STRENGTHENING DETAILS - 2  
BRIDGE NO. LAK-90-2342 R  
OVER THE GRAND RIVER

LAK-90-23.42 L&R

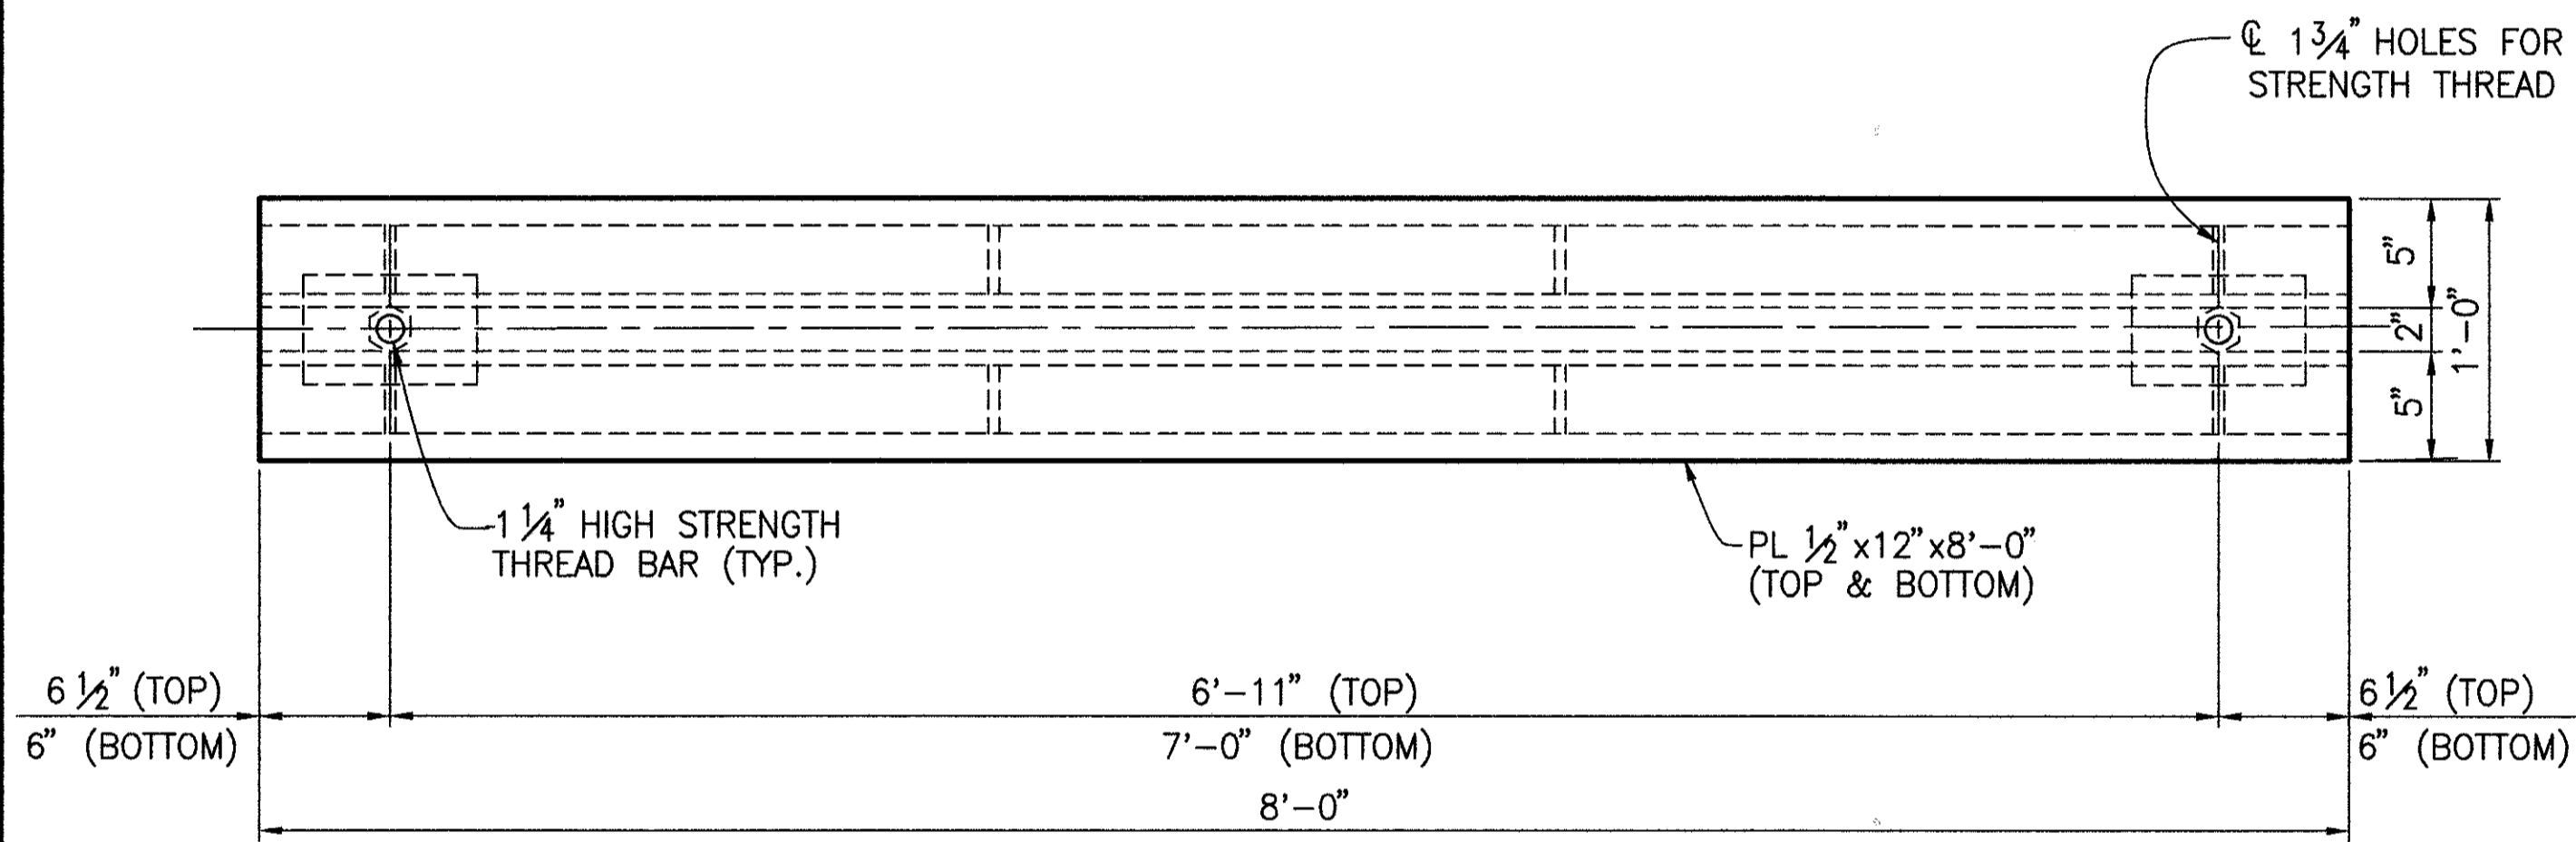
\*DIMENSION SHOULD HAVE BEEN LARGER TO PROVIDE MORE EDGE DISTANCE.
